CONWAY
HISTORIC DISTRICT COMMISSION

JANUARY
STAFF REPORT

I. Binnie Residence - New Attached Garage & Drive - 1613 Simms Street

OLD CONWAY DESIGN OVERLAY DISTRICT CERTIFICATE OF APPROPRIATENESS REVIEW

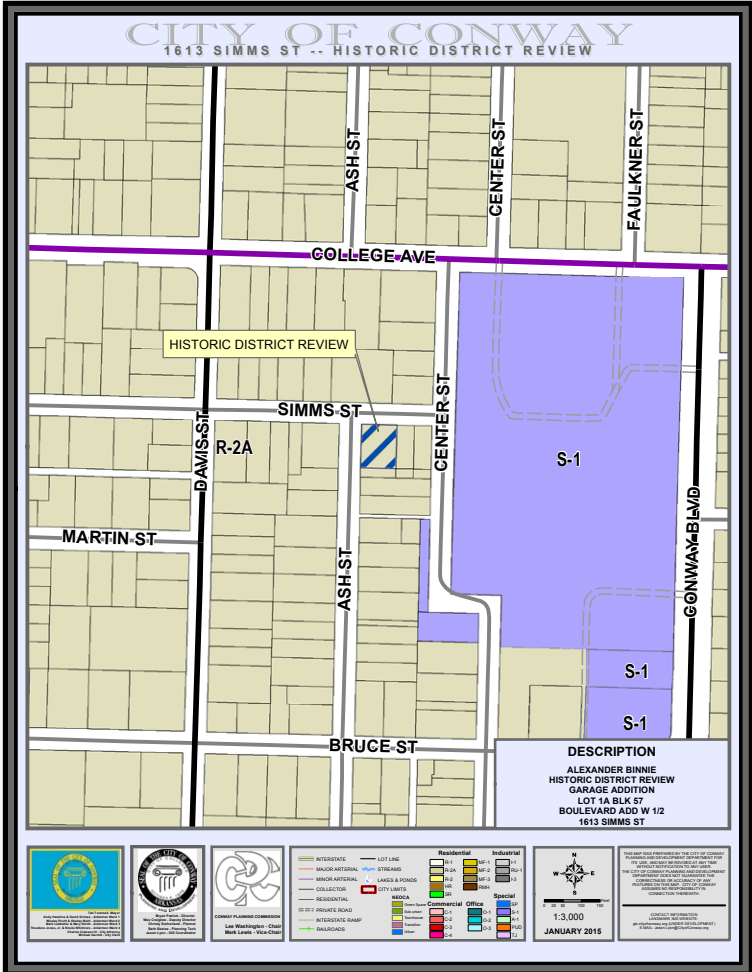
General description of property and proposed development: The applicant would like to construct a garage/utility room addition onto the west side of the existing single family residence. There was a freestanding carport in the same general area that was recently demolished.

Setbacks: Proposed structures should respect the predominant setbacks of area structures, especially the front setback. Old Conway suburban guidelines state that the front of a structure should be between 80% and 110% of the average area front setback of 20 feet from the property line. The addition will not affect the front setback. The rear and east setback of the addition remain unchanged. The new garage addition will be approximately 5.5 feet from the property line or 26 feet from the curb. The garage will protrude approximately 2 feet further to the west than the former carport. This west setback seems appropriate.

Driveway / Parking: The Old Conway Guidelines encourage freestanding garages at the rear of structures or at least set back from the front facade. The garage should not be the most emphasized feature of the front facade. The addition/garage will face west towards Ash Street. The garage will be accessed via Ash Street with a new driveway. The residence's front facade will remain unchanged. Guidelines also require a garage to be placed at least at the mid-line of the structure to deemphasize the mass of the garage along the front facade.

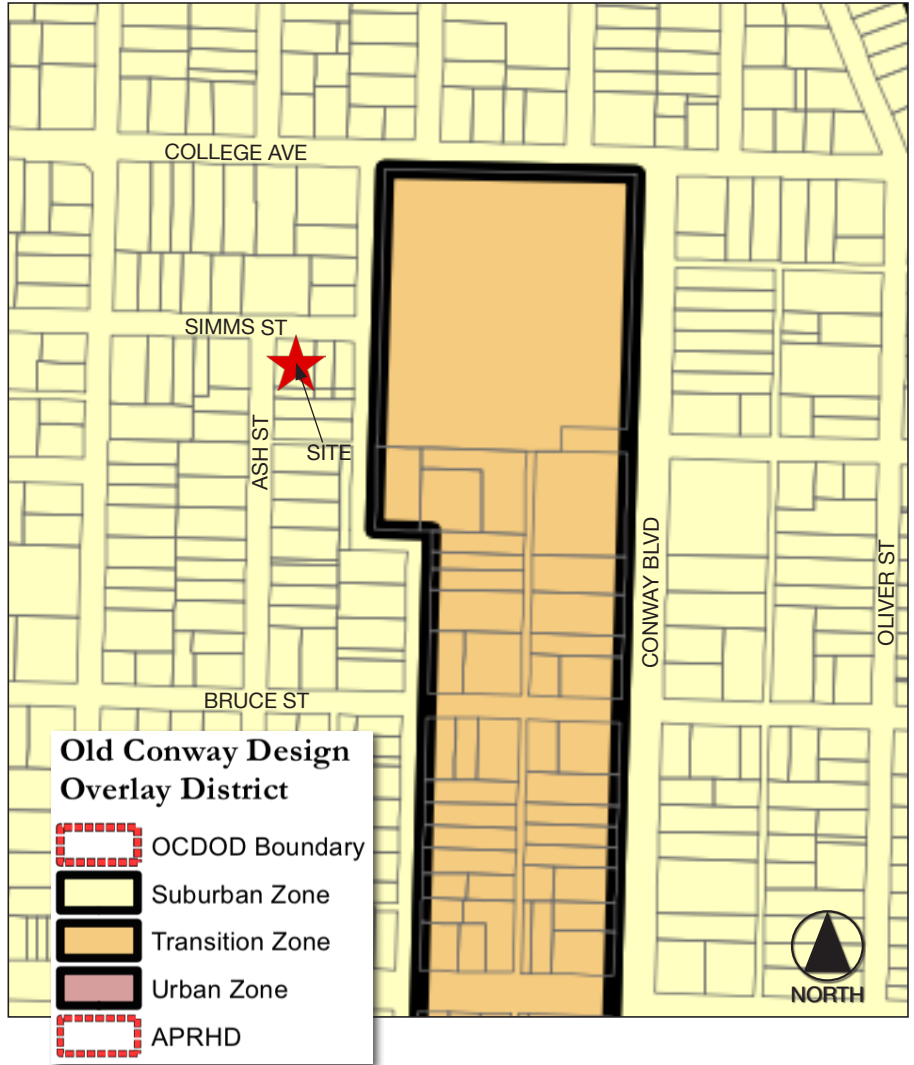
Façade, wall area, rhythm: Facades shall be compatible with surrounding historic structures in proportion of wall to opening area. Window and door openings should correspond to the rhythm and proportion on existing structures. Generally doors and windows should be proportioned in a range of 25-40% of the total surface area. Although the majority of the addition is used as a garage, consideration should be given to requiring an additional window on the Ash Street facade. It appears that two windows will be removed from the west facade. One could be reused on the garage facade as shown on the staff sketch. Additionally, the entry door could be at least half glass to create more window area on the north facade.

1. The addition shall be constructed as submitted
2. Any site lighting shall be inward, downward, and shrouded.
3. One additional window shall be provided as shown on staff sketch. Re-use of one of the original historic windows is encouraged.
4. The new entry door shall have 50% glass minimum.
5. HVAC equipment shall be appropriately screened and located at the rear.
6. Matching asphalt shingles shall be used.
